# UNITED STATES PATENT AND TRADEMARK OFFICE

APPLICATION NO.	FILING DATE	FIRST NAMED INVENTOR	ATTORNEY DOCKET NO.	CONFIRMATION NO.
10/537,937	01/19/2006	Bruno Egner-Walter	VAL 204 P2	8638
34232	7590	01/23/2008		
MATTHEW R. JENKINS, ESQ. 2310 FAR HILLS BUILDING DAYTON, OH 45419			EXAMINER FERGUSON, MICHAEL P	
			ART UNIT 3679	PAPER NUMBER
			MAIL DATE 01/23/2008	DELIVERY MODE PAPER

<b>Office Action Summary</b>	<b>Application No.</b> 10/537,937	<b>Applicant(s)</b> EGNER-WALTER ET AL.	
	<b>Examiner</b> MICHAEL P. FERGUSON	<b>Art Unit</b> 3679

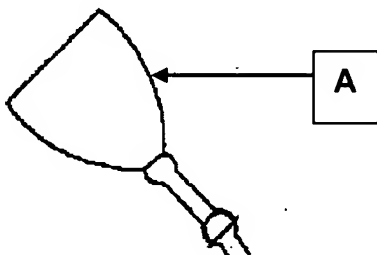
As to claim 2, Hathaway discloses a ball pin system wherein a second pin is fit into the first recess **32** (Inherently, a tubular connector element, housing the power cord attached to lamp head **A**, is fit into a first recess **32**. The tubular connector element constitutes a second pin; Figure 3B reprinted below with annotations). Hathaway fails to disclose a ball pin system wherein a second pin is knurled and press-fit into the first recess.

REPLACEMENT DRAWING SHEETS  
IN RESPONSE TO OFFICE ACTION OF 07/12/2007  
Serial No. 10/537,937  
Filed January 19, 2006

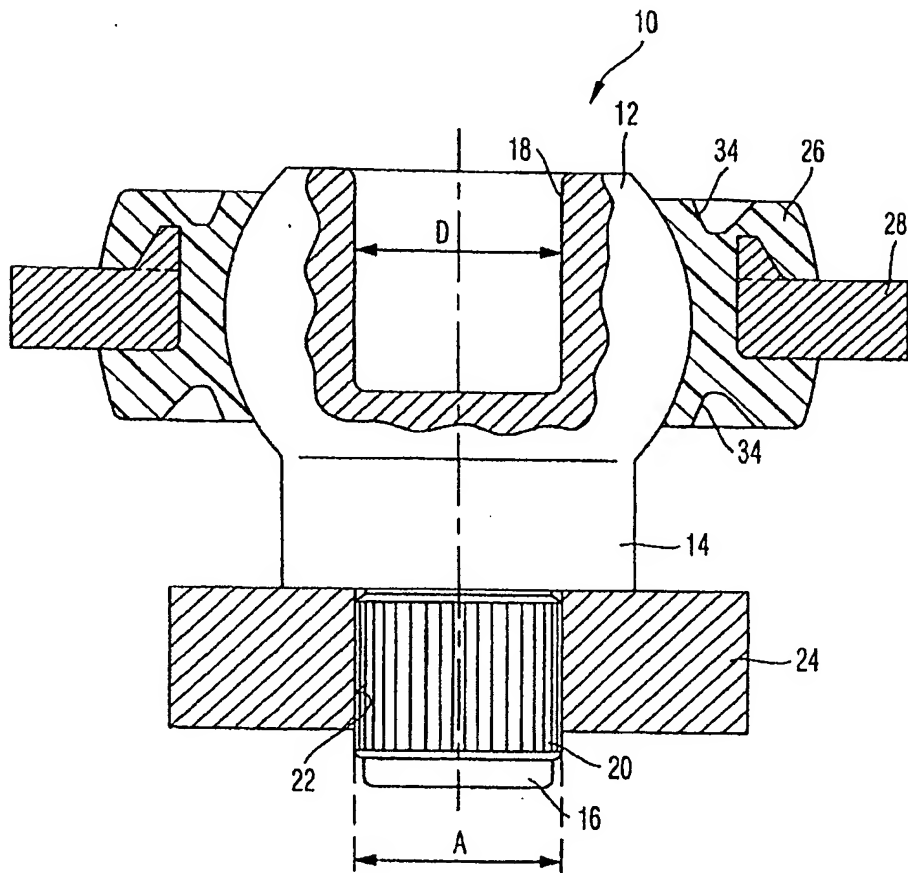
Elements **30,32**, shown in cross-sectional view in Figures 2, 4 and 5 of the replacement drawings filed October 11, 2007, lack proper cross-hatching based on the material of such elements. Accordingly, the replacement drawings have not been approved.

NOT  
APPROVED.  
NTP  
1/16/08

Corrected drawing sheets in compliance with 37 CFR 1.121(d) are required in reply to the Office action to avoid abandonment of the application. Any amended replacement drawing sheet should include all of the figures appearing on the immediate prior version of the sheet, even if only one figure is being amended. The figure or figure number of an amended drawing should not be labeled as "amended." If a drawing figure is to be canceled, the appropriate figure must be removed from the replacement sheet, and where necessary, the remaining figures must be renumbered and appropriate changes made to the brief description of the several views of the drawings for consistency. Additional replacement sheets may be necessary to show the renumbering of the remaining figures. Each drawing sheet submitted after the filing date of an application must be labeled in the top margin as either "Replacement Sheet" or "New Sheet" pursuant to 37 CFR 1.121(d). If the changes are not accepted by the examiner, the applicant will be notified and informed of any required corrective action in the next Office action. The objection to the drawings will not be held in abeyance.
